CS9200 Box Modification for Mazda CX-5, Mazda 6, Sony-USB

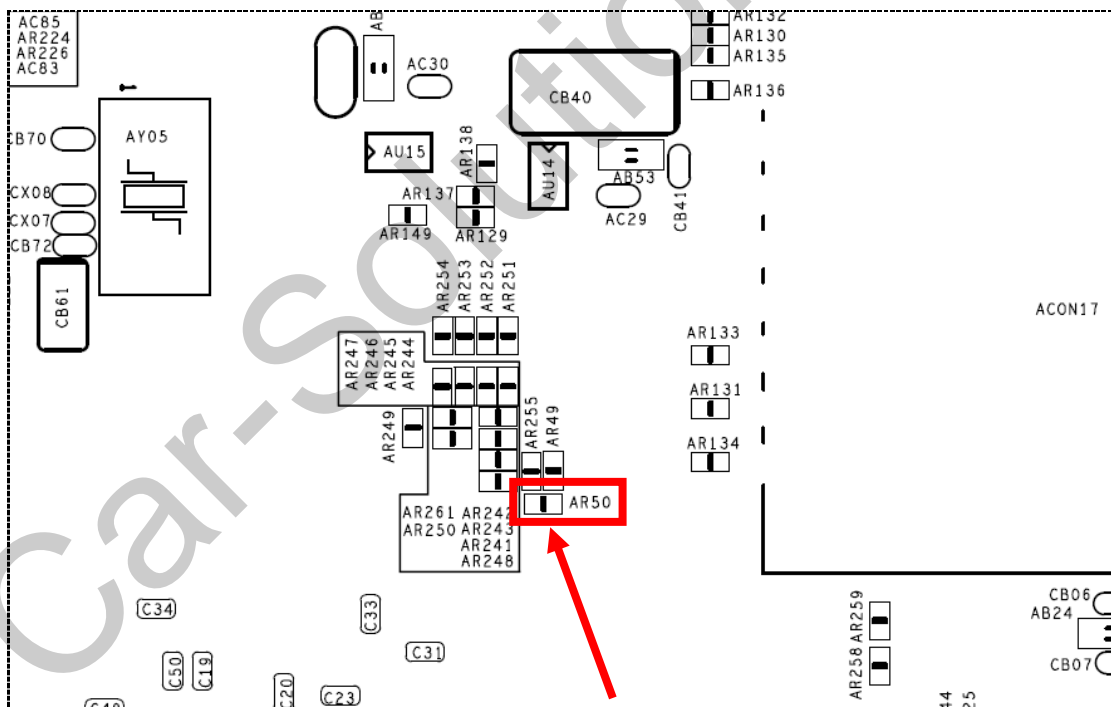
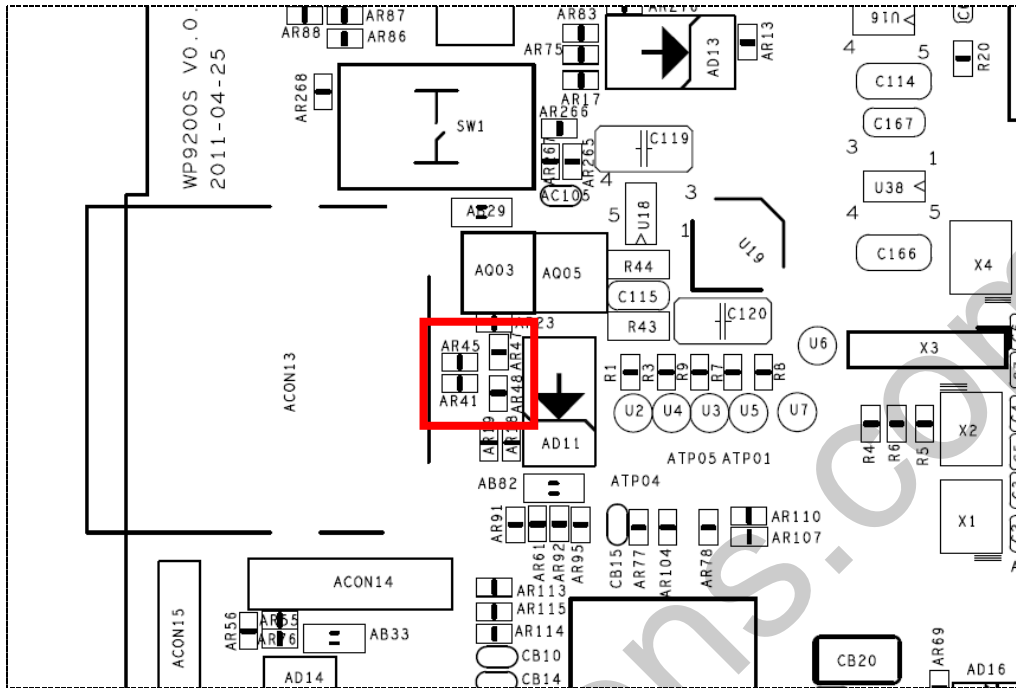
Component	Action	Board layer
AR41 (22R)	Replace by 0R resistor (<i>short out</i>)	Top (USB)
AR45 (22R)	Replace by 0R resistor (<i>short out</i>)	Top (USB)
AR47 (15k)	Desolder	Top (USB)
AR48 (15k)	Desolder	Top (USB)
AR50 (0R)	Desolder	Bottom (SD-card)
